PRELIMINARY SITE PLANS

PRIMROSE SCHOOL

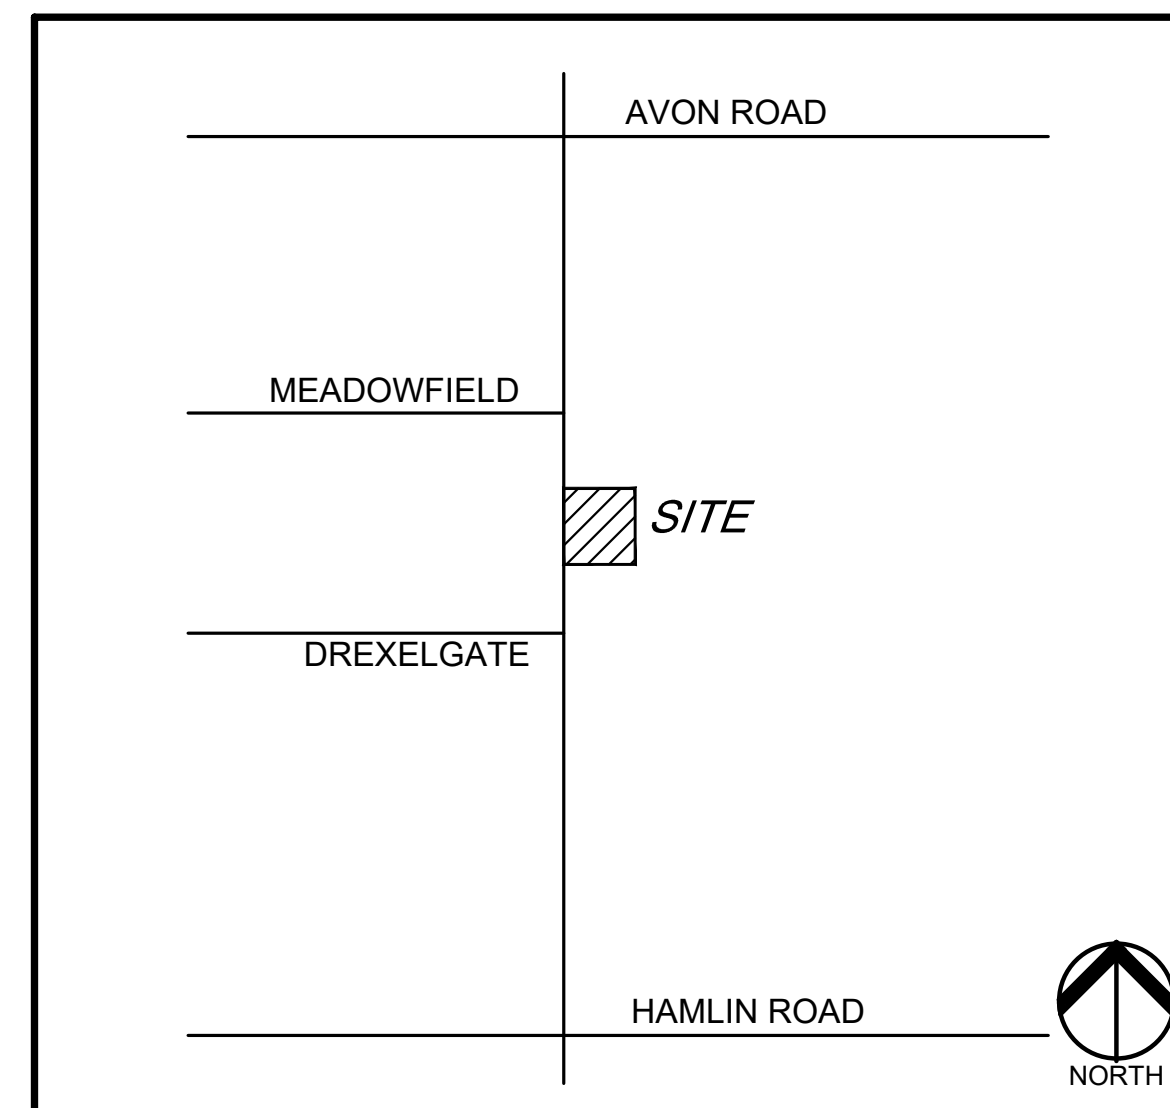
All plan review comments must be addressed prior to scheduling for the Planning Commission, unless otherwise noted.

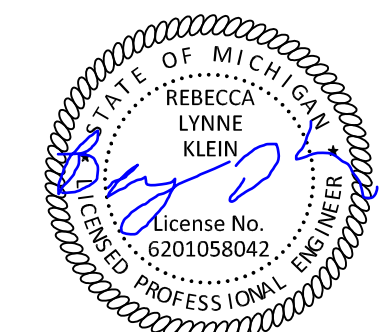
The applicant needs to submit a Land Improvement Permit (LIP) application with engineer's estimate, fee and construction plans to proceed with the construction plan review process.
